Considerations and discussion around an optimized link budget for 400GBASE-DR4

- towards TX OMA reduction and PAM4 PMDs alignment -

400GBASE-DR4: 802.3bs draft 1.0 link budget.

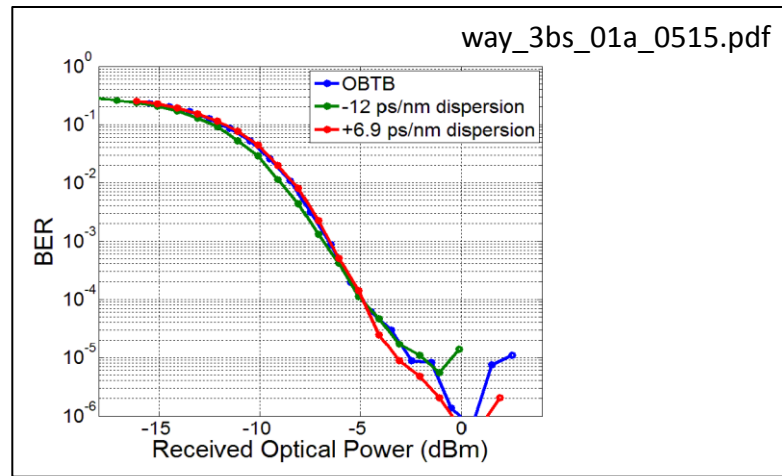
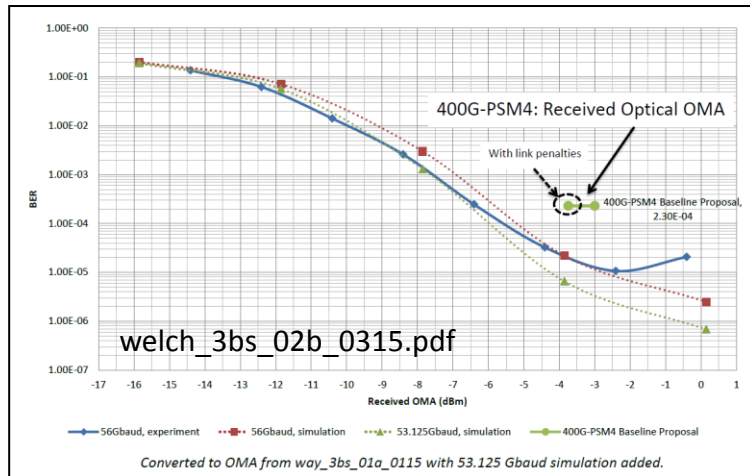
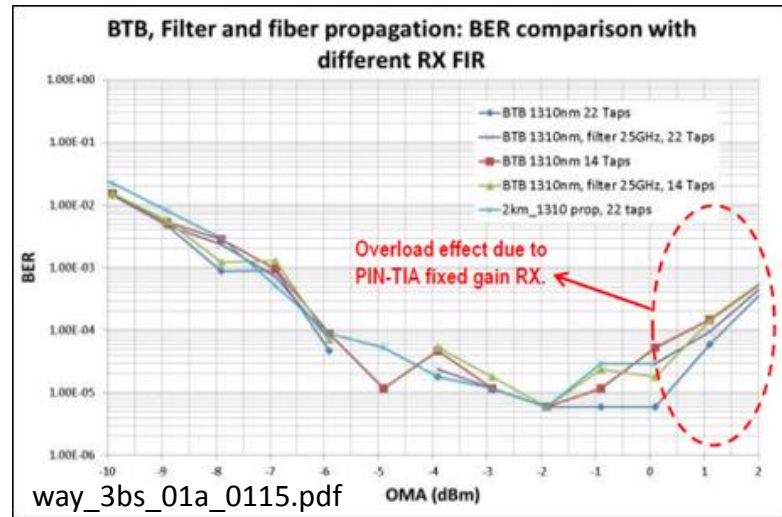
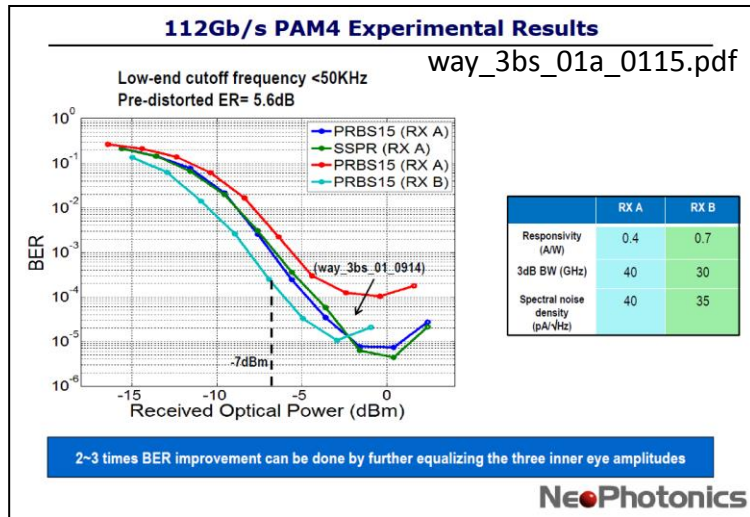
Current 400GBASE-DR4 link budget includes a margin of 0.15dB ($[TX\ OMA_{inner} - TDP] - CH\ IL - RX\ Sens$) which takes into account MPI penalty (0.5dB) into.

Proposed 400GBASE-DR4 link budget.

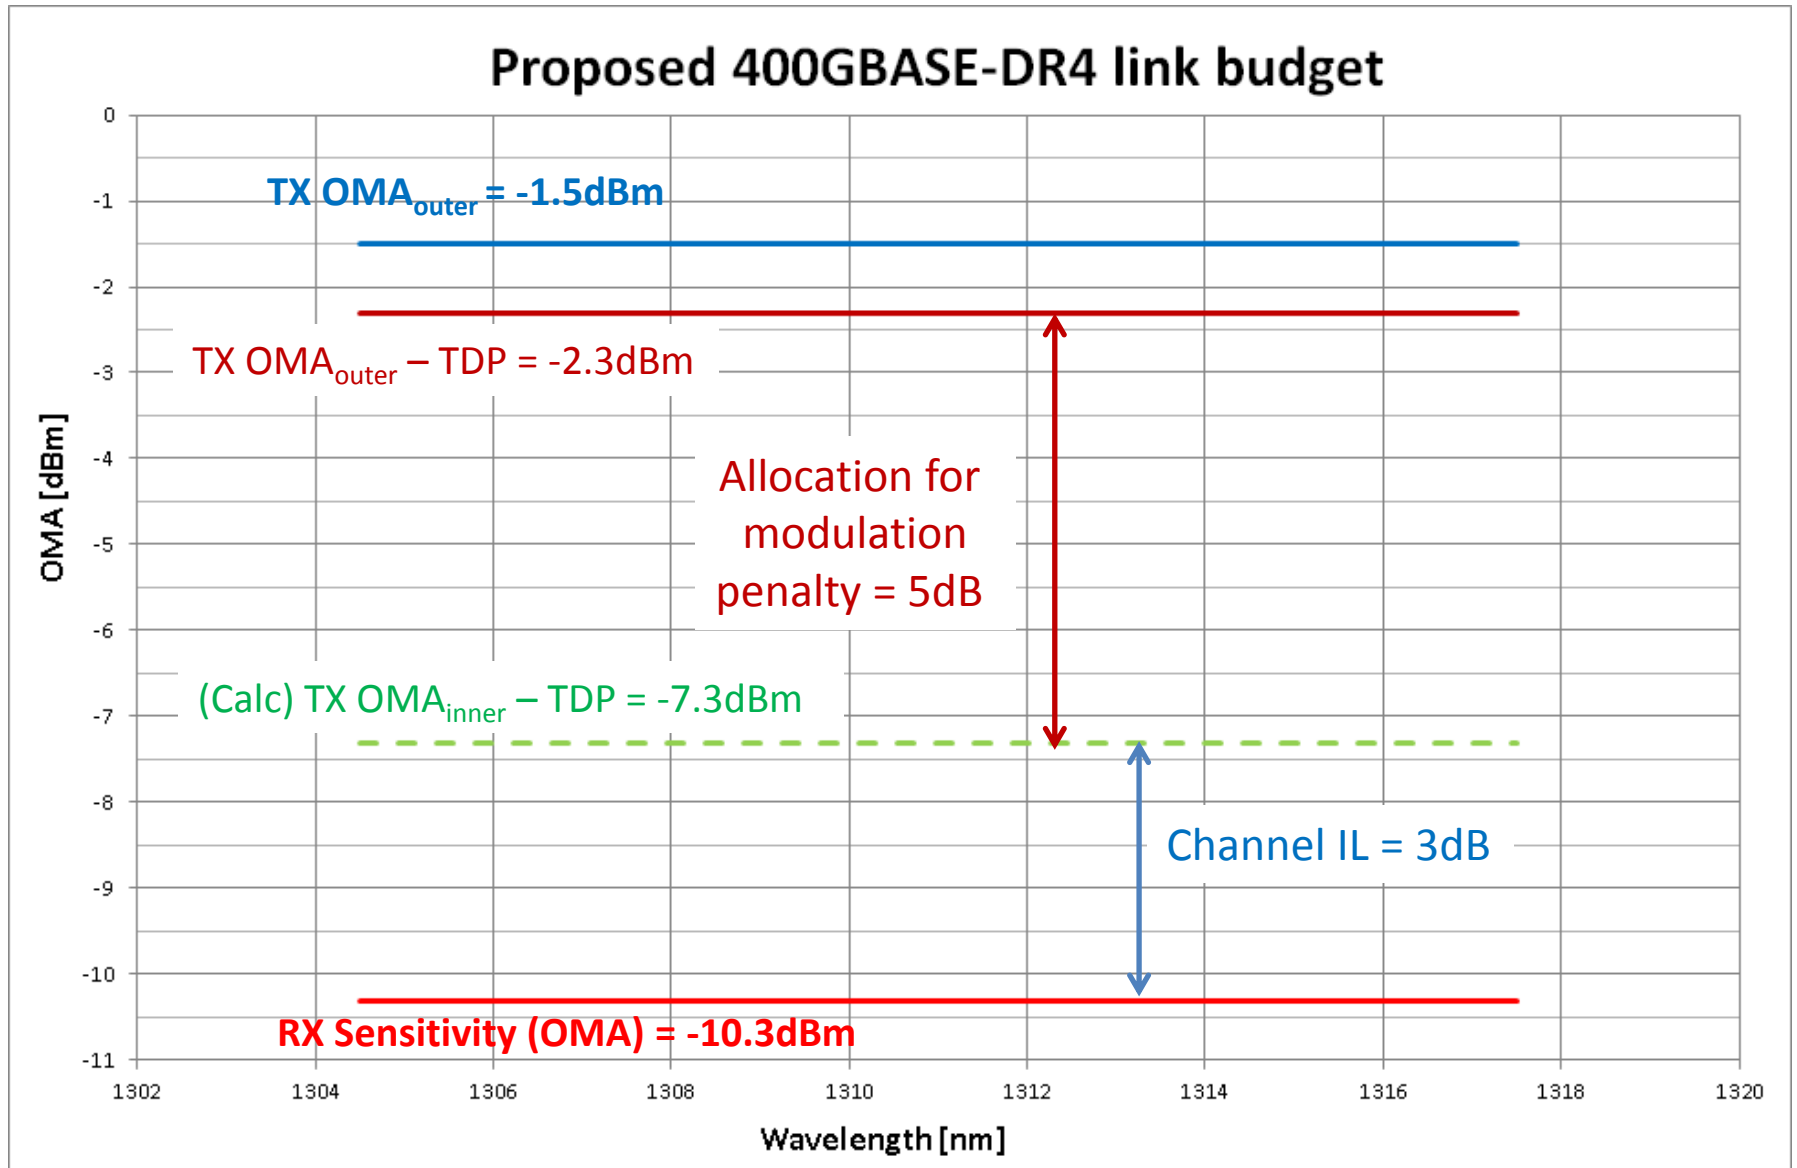
- Take out any residual margin from current 400GBASE-DR4 budget (0.15dB)
- Incorporate MPI penalty into max TDP of 2.5dB (0.5dB)
- Consider the same PAM4 implementation penalty as for 400GBASE-FR8/LR8 (delta of 0.2dB).
- Reduce TX OMA by 1.5dB;
- Improve RX sensitivity by 1.05dB;

- Table 122-6:
 - TX OMA_{outer} : from 0 to -1.5dBmConsequently TX OMA_{inner} will be reduced, but we indeed propose to:
 - remove TX OMA_{inner} from table 122-6 and replace with OMA_{outer} – TDP = -2.3 dBm.
 - Incorporate MPI penalty into max TDP penalty of 2.5dB.
- Table 122-7:
 - RX sensitivity (OMA_{inner}) : from -9.25 to -10.3dBm
- Table 122-8:
 - Add : Allocation for modulation penalties = 5dB.
